Chabot-Las Positas Community College District

CHANGE ORDER

OWNER	Chabot Las Positas Community College District	Contract # 552315
ARCHITECT	Harley Ellis Devereaux	Architects Project #:2015-30004-000
CONTRACTOR	W. A. Thomas Co. Inc.	DSA File # 1 - C2
		DSA App. # 01-116361

PROJECT:	Biological Sciences Building Annex B2100 Phase 1	CHANGE ORDER NUMBER: 013 INITIATION DATE: September 30, 2021
-----------------	---	---

Harris RFI 155 Potential Pump Enclosure

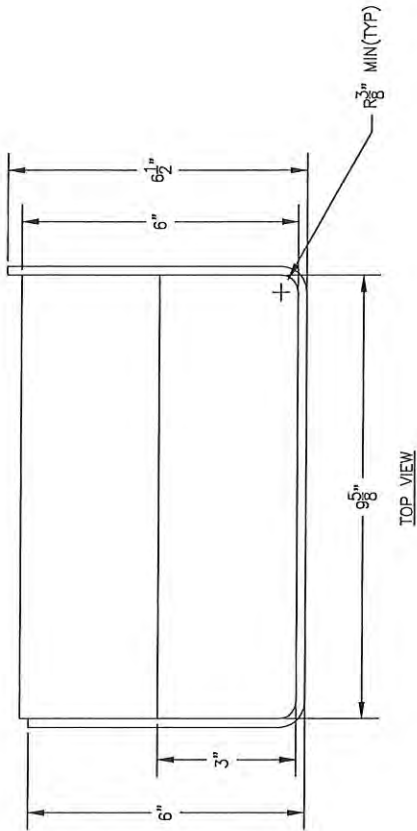
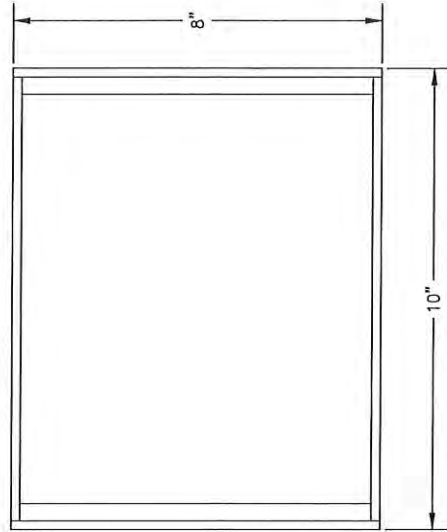
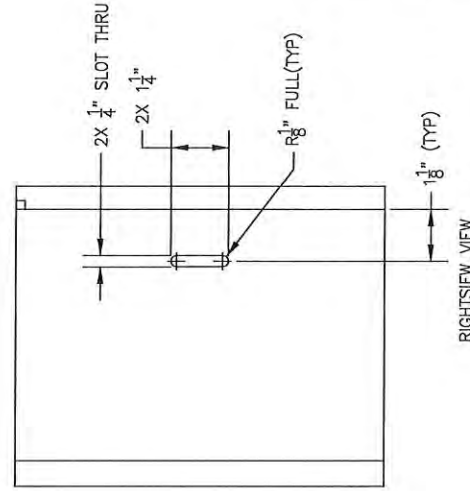
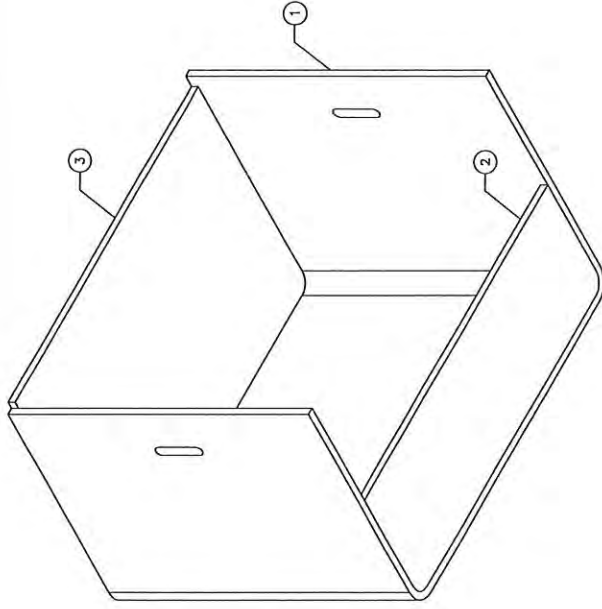
Harris provided the model specified on the M-003 schedule with epoxy coated volutes to meet the Marine Environment Construction note on the schedule.

Despite the epoxy coating for marine environments, these pumps are not recommended to be installed in outdoor conditions for risk of damage from environmental conditions.

The supplying vendor has found an outdoor enclosure that could be suitable for these pumps to operate in outdoor conditions. (See Attachment)
